## **BYRUM FAMILY DIVISION SUBDIVISION**

APPLICATION NUMBER 14 DATE July 11, 2013  
APPLICANT Byrum Family Division  
REQUEST Subdivision

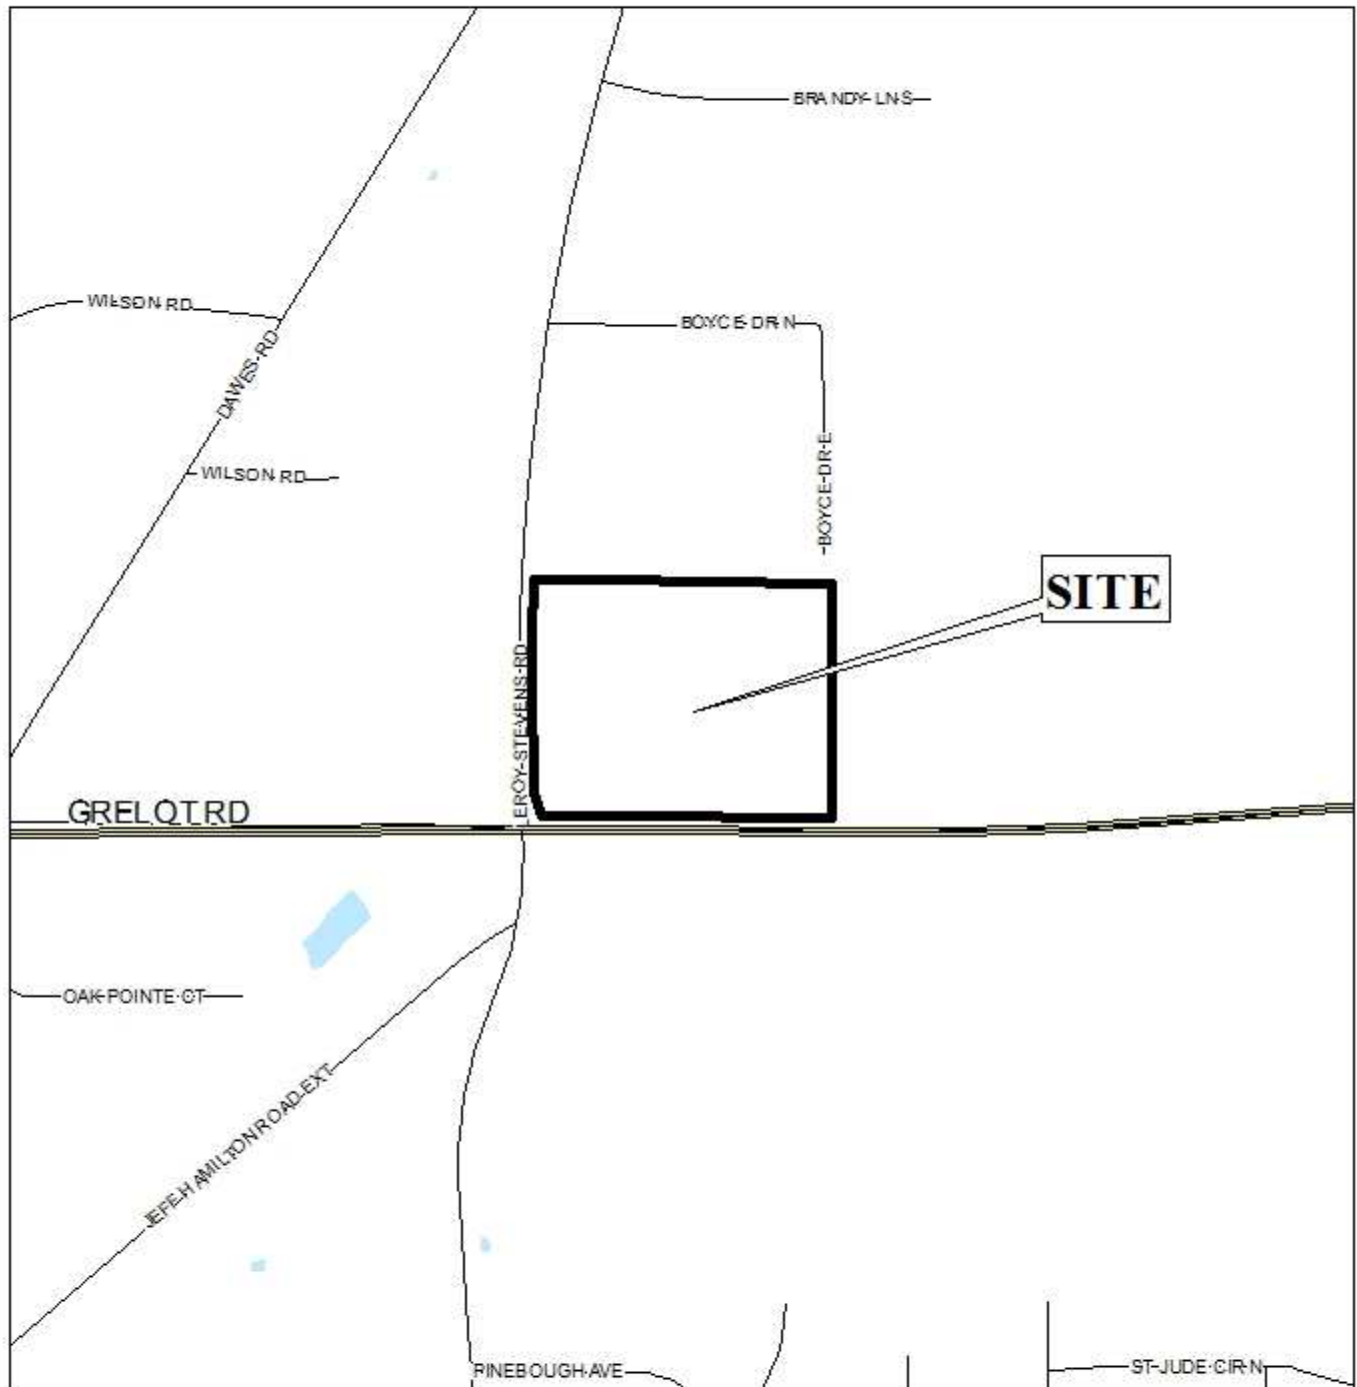
The intent of this application is to create two legal lots of record from four meets-and-bounds parcels. In accordance with the Subdivision Regulations, both lots are compliant with the minimum size requirements. The 25-foot minimum building setback line and the lot sizes in square feet are illustrated on the preliminary plat for both lots and should be retained on the Final Plat.

Lot 1 has  $750 \pm$  feet of frontage along Grelot Road and  $300 \pm$  feet of frontage along Leroy Stevens Road. As a means of access management, a note should be placed on the Final Plat limiting Lot 1 to three curb-cuts along Grelot Road and one curb-cut along Leroy Stevens Road and Lot 2 to be limited to 2 curb-cuts along Leroy Stevens Road. The size, location and design to be approved by Mobile County Engineering and conform to AASHTO standards.

It should be noted that there appears to be discrepancies in the legal description and the vicinity map on the preliminary plat. On the northeast corner of the intersection of Grelot Road and Leroy Stevens Road, the legal descriptions states that the southwest property line runs  $S24^{\circ}26'59''E$ , however, the preliminary plat depicts the property line running  $N24^{\circ}26'59''W$ . At the same intersection, the vicinity map does not include the corner parcel which is shown on the preliminary plat. The Final Plat should be revised to illustrate the correct bearings of the

southwest property line and the vicinity map should be corrected to include the corner parcel for the same intersection.

- 1) a provision of a corner radius at the intersection of Grelot Road and Leroy Stevens Road be approved by Mobile County Engineering and comply with AASHTO standards;

- 2) revision of the lot size and the 25-foot minimum building setback line reflect the corner radius of Lot 1, and should be retained elsewhere on the Final Plat;

- 3) the Final Plat should be revised to illustrate the correct bearings of the southwest property line at the intersection of Grelot Road and Leroy Stevens Road and the vicinity map should be corrected to include the corner parcel for the same intersection;

- 4) placement of a note on the final plat limiting Lot 1 to three curb-cuts along Grelot Road and one curb-cut along Leroy Stevens Road and Lot 2 to be limited to 2 curb-cuts along Leroy Stevens Road. The size, location and design to be approved by County Engineering and conform to AASHTO standards;
